# Access Compliance Report

## Public Rights-of-Way

### (Curb Ramps)

Intersection ID: 5092	Main Street: BROOKFIELD_POINTE_DR	Cross Street: PENNYCROSS_LN	Location: NE
ADA ID: A27CA7672F91	Ramp Type: Perp	Initial Pass/Fail: Fail	Overall Compliance: No
Severity Score: 1.25			
Codes/Mitigation Info/Possible Solution		Field Measurements/Component Compliance

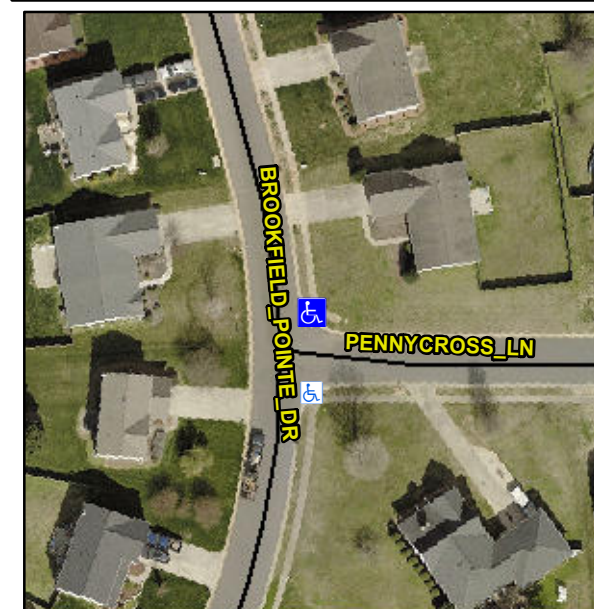
**Not Found, R304.5.3**

Compliance	Description	Data	Compliance	Description	Data
N/A	Ramp Length (in)	87.0	Yes	Ramp Slope (%)	5.8
Yes	Ramp Width (in)	48.0	No	Ramp XSlope (%)	3.2
N/A	Flare Type LT	N/A	N/A	Flare Type RT	N/A
N/A	Flare Slope LT (%)	N/A	N/A	Flare Slope RT (%)	N/A
N/A	Flare Traversable LT?	N/A	N/A	Flare Traversable RT?	N/A
N/A	Landing Length (in)	N/A	N/A	DWS Provided?	N/A
N/A	Landing Width (in)	N/A	N/A	DWS Contrast?	N/A
N/A	Landing Slope (%)	N/A	N/A	DWS Length (in)	N/A
N/A	Landing X Slope (%)	N/A	N/A	DWS Full Width?	N/A
N/A	Landing Curb? (Y/N)	N/A	N/A	DWS Offset (in)	N/A
N/A	Shared Landing?	N/A			
N/A	Gutter Ponding?	N/A	N/A	Gutter Slope (%)	N/A
N/A	Gutter Lip Ht (in)	N/A	N/A	Gutter X Slope (%)	N/A
N/A	Painted X Walk1?	No	N/A	Painted X Walk2?	N/A
	X Walk 1 Direction	To S		X Walk 2 Direction	N/A
N/A	X Walk 1 Width (in)	N/A	N/A	X Walk 2 Width (in)	N/A
	X Walk 1 Slope (%)	1.2		X Walk 2 Slope (%)	N/A
	X Walk 1 X Slope (%)	1.3		X Walk 2 X Slope (%)	N/A

**Remove & Replace Entire Ramp.**
